Jackson Town Council Regular Meeting

April 17, 2023

P22-253 Development Plan for 245 and 265 N. Millward St. – Continued. Paul Anthony, Katelyn Page, and Brian Lenz made staff comment. Adam Janak, Hans Flinch, Patrick Woodward, and Josh Kilpatrick made applicant comment. Rose Robertson, Kimberly Kernan, Matt Gaffney, Stuart Suna, John Bickner, Diana Welch, Matt Bambach, and Eugenie Copp made public comment. Council asked questions of staff. A motion was made by Arne Jorgensen and seconded by Jessica Sell Chambers to continue P22-253 to the regularly scheduled Town Council meeting on April 17, 2023. Mayor Morton Levinson called for the vote. The vote showed all in favor. The motion carried.

A0.01

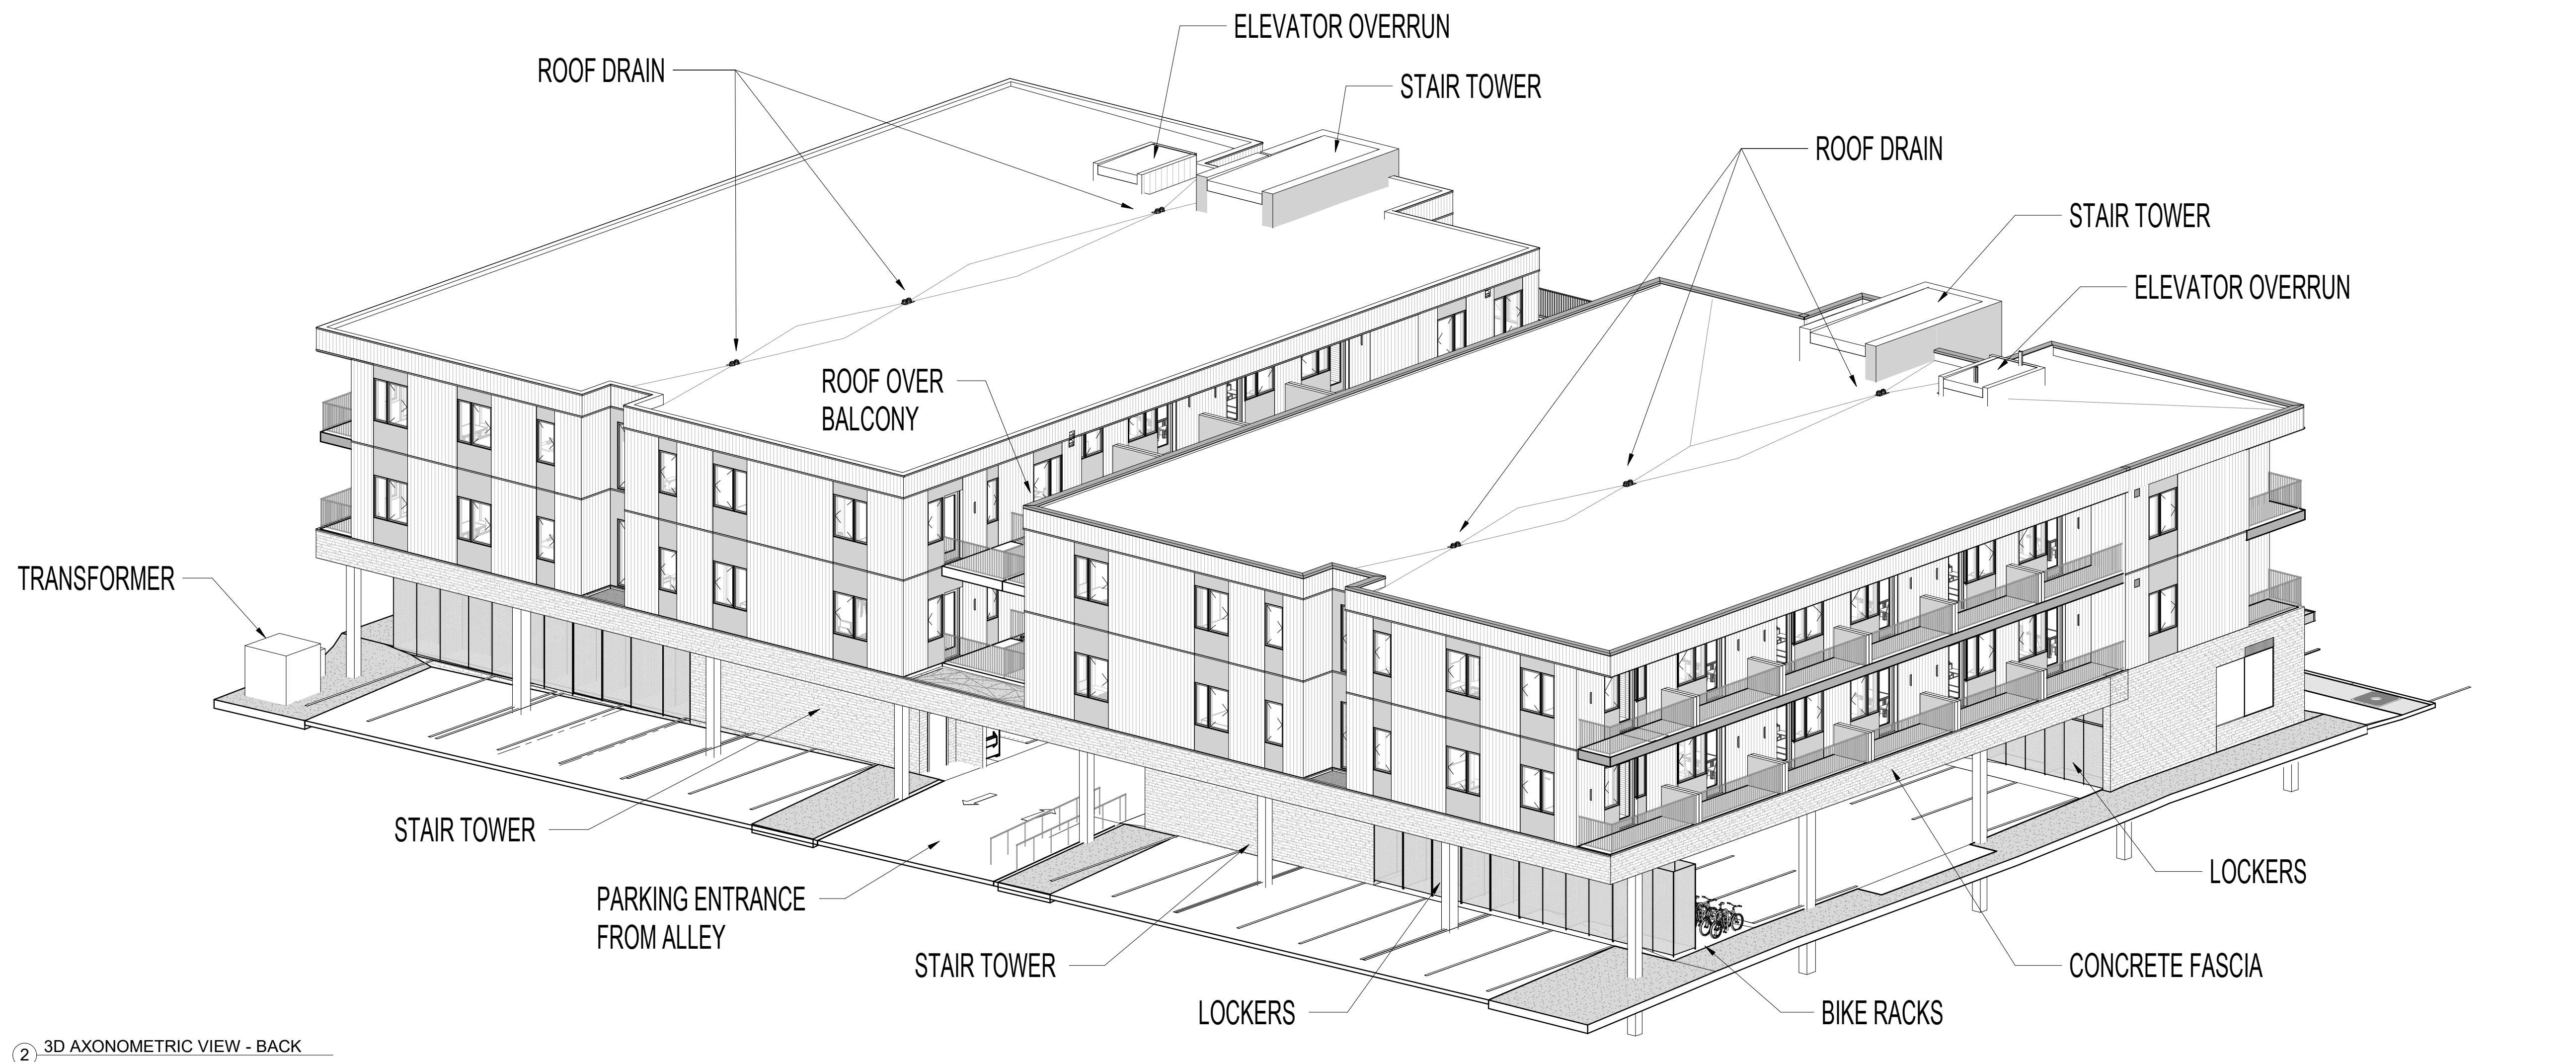
- P.42, 43, 47 (A0.01, A0.10, A1.50) – **Reduced the building’s bulk along the alley facade.**
The central balconies were pushed back to introduce more planted green space along the alley. Deeper setbacks were also introduced at the two residential corridors, where more greenery was added and the roof overhang removed. The third-floor balcony roof was removed to reduce bulk at the courtyard.
- P. 44-45 (A1.01-A1.02) & P. 70-77 (L0.2-L4.1) – **LSR area was increased, parking spaces removed, and snow storage added.** The side yards are now planted along the full length of the property to the north and south. The 10% LSR requirement is now met at ground level.

A1.01

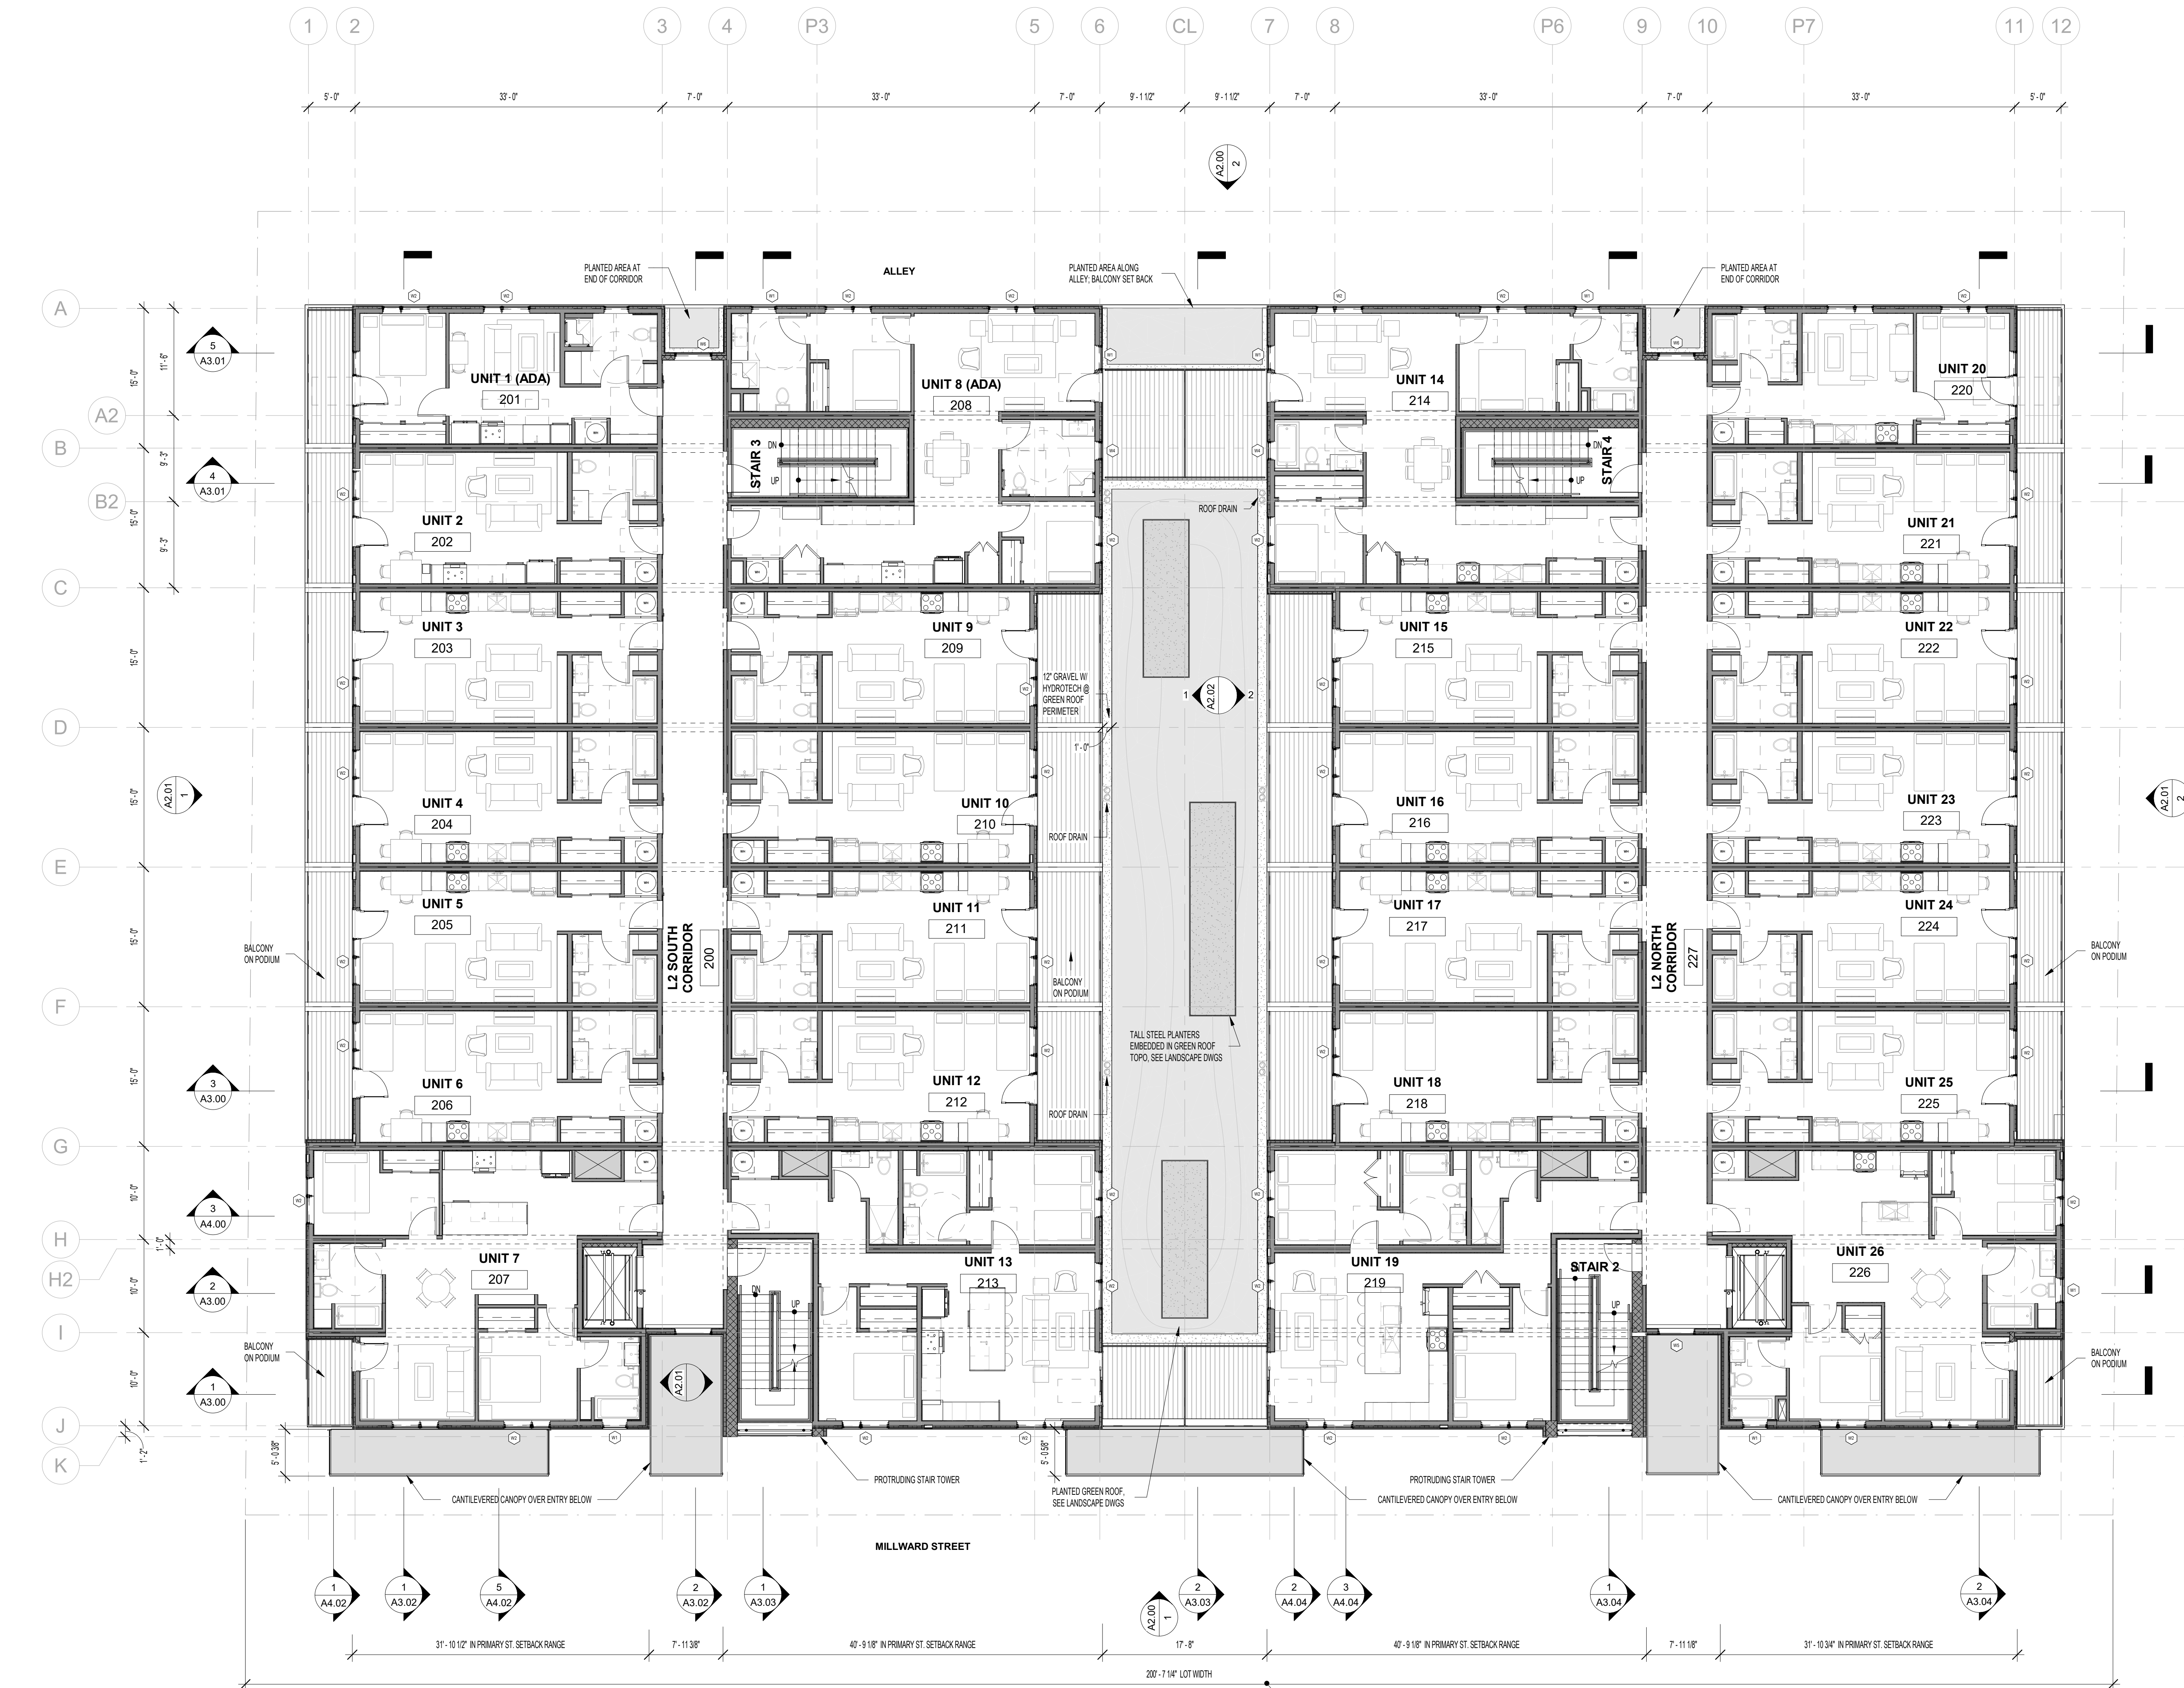
- 1) A1.01: Potential conflict with building columns and vehicle doors. Review and revise accordingly.
- 2) C1.1 - Construction Tracking Pad detail is not feasible in this location and conflicts with the proposed grates in the construction management plan. Review and revise accordingly.

- Planning Dept. highly suggests incorporating screening between the parking facility and side property lines. Consider fencing or landscaping options. **Planted areas have been extended along the north and south property lines, as shown in A1.01 and L0.3 and L4.0.**

- Revise plans to show dimension for distance between eastern property line and building. **Updated on A1.01.**
- Revise plans to show distance between existing "encroaching building" to the south and the proposed structure on 245 / 265 N. Millward. **Updated on A1.01.**

- Revise plans to show dimensions of on street parking spaces. **Updated on A1.01.**
- Revise plans to show dimensions of shorter compact parking spaces. **Updated on A1.01.**

- Please verify consistent dimensions for parking spaces in parking facility. It appears dimensions vary across different plans. **Updated on A1.01.**
- Revise ADA van space to be 8' wide with min 8' adjacent aisle. (11' + 5' shown). **Updated on A1.01.**

- Maximum of 8 compact parking spaces are allowed for parking plan with total of 54 onsite spaces. 9 are shown. **On A1.01, the column grids and parking layout were updated so that we now only have 6 compact spaces.**

- Update all plans (civil, landscape, architecture) to consistently show location of ADA and compact spaces. **Updated architecture, civil, and landscape sheets. See A1.01.**

- Applicant may apply parking facility dimensions provided in Resolution 09-25 for covered parking facilities. Applicant may choose to adjust plans to reflect Resolution 09-25 standards. **Updated on A1.01.**

- Revise plans to include 2' wheel stops at minimum for any parking space where vehicle overhang would impede amenities like walkways, storage locker doors, or bike rack (etc.). Planning Dept. suggests adding 2' wheel stops for all parking spaces. **Updated on A1.01.**

- P. 44 (A1.01) – **Fencing was added along the north and south property lines.**
Six-foot fencing was added to further screen the parking area and transformer.
- P. 44 (A1.01) – **Hammerhead parking turnouts were added.**
These are 3’-8” deep and 14’-0” wide, which allow for proper vehicle turning per the Civil turning analysis diagrams.
- P. 44 (A1.01) – **Two laundry rooms were combined into one central room.**
A fire riser room was also added next to the laundry room.
- P.46 (A1.03) – **Reduced unit count to 48 units.**
The four interior courtyard corner units on Level 3 were combined with adjacent studios to
